**W3F1-2000-0101**  
**A4.05**  
**PR**

**Subject: Waterford 3 SES**  
**Docket No. 50-382**  
**License No. NPF-38**  
**Response to Request for Additional Information Related to**  
**Technical Specification Change Request NPF-38-206 Regarding**  
**the Emergency Feedwater System (TAC No. MA2189)**

**Response to Request for Additional Information Related to  
Technical Specification Change Request NPF-38-206  
Regarding the Emergency Feedwater System**

**FIGURE 1 - Time Charts for Steam Generator Fill**

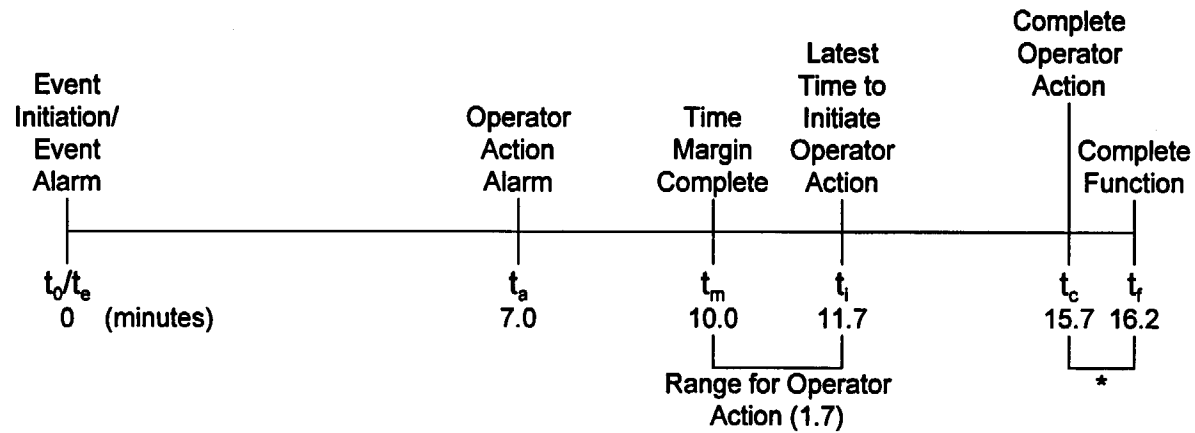
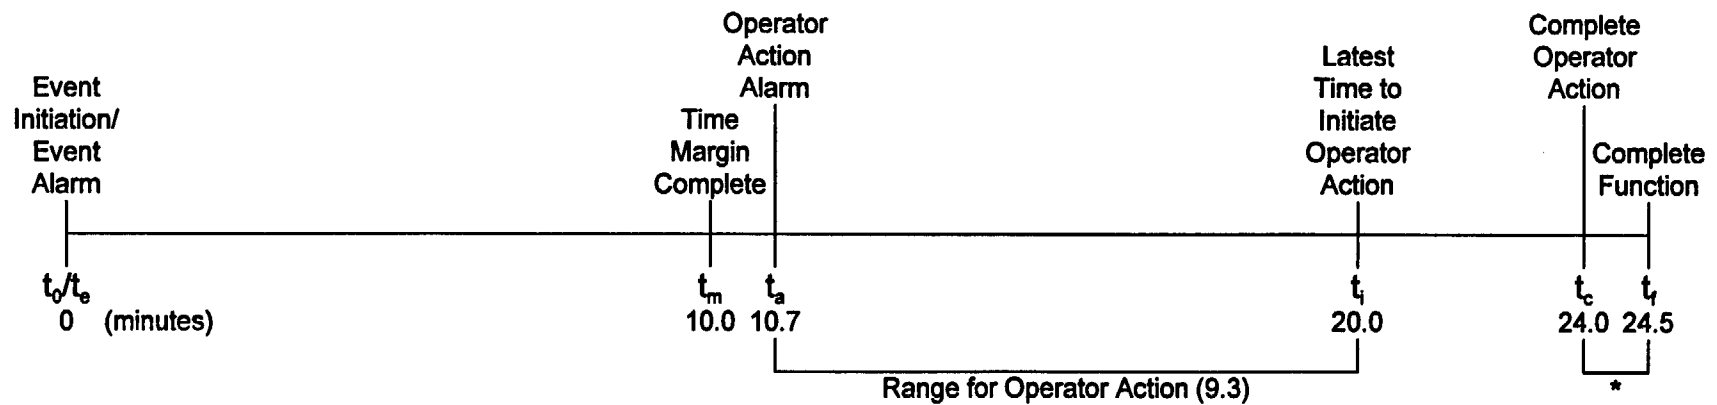
- a. What is the meaning of "greater" in "greater than 13 minutes?" - how much greater than 13 minutes?
- b. American National Standards Institute/American Nuclear Society (ANSI/ANS Standard ANSI/ANS-58.8-1984 shows a minimum of 10 minutes for Time Test #1 (Plant Condition 3, Loss of Off-site Power (LOOP)). Added to that would be a minimum of four minutes for Time Test #2 (PC 3, LOOP, one manipulation). Added to that would be one minute per additional operator manipulation. Added to that would be equipment process time. Assuming only one manipulation and no equipment process time, the result is already at 14 minutes. Please explain how you arrived at a time delay of from two to six minutes using the referenced standard.

Should you plan to take exception to the time criteria of ANSI/ANS-58.8-1984, it is necessary to justify the exception by developing operator action times based on a task analysis and an independent data base. Please provide the justification for this exception.

Please provide a time criteria in accordance with the provisions of ANSI/ANS-58.8-1984 with the maximum EFW flow of 2300 gallons per minute to a single steam generator during a main steam line break.

The revised values for operator action time calculated from the re-evaluation of SG fill rates (see Response a above) have been compared to the recommendations of ANSI/ANS-58.8-1984 and are provided in Figure 1. This comparison is based on one operator action in the control room to close the open isolation valve. An equipment process delay time of 30 seconds for the isolation valve to close is conservatively used.

Figure 1 provides a comparison to ANSI/ANS-58.8-1984 Figure 2 for the highest SG fill rate at 200 psig and the SG fill rate that is associated with 1000 psig. The Range for Operator Actions for these two cases is 1.7 minutes and 9.3 minutes, respectively. The figure shows that the guidelines in the ANSI/ANS standard are met. Accordingly, the times allow credit for manual operator action in these events.

This scenario has been replaced by the re-evaluation described in the Response to Request 1 above. The EFW flow rate was dependent on the SG pressure. The maximum EFW flow rate at the pressure that resulted in the shortest time to overfill was used. A comparison to the time criteria of ANSI/ANS-58.8-1984 for the re-evaluated SG fill rates is provided as part of the Response to Request 1.
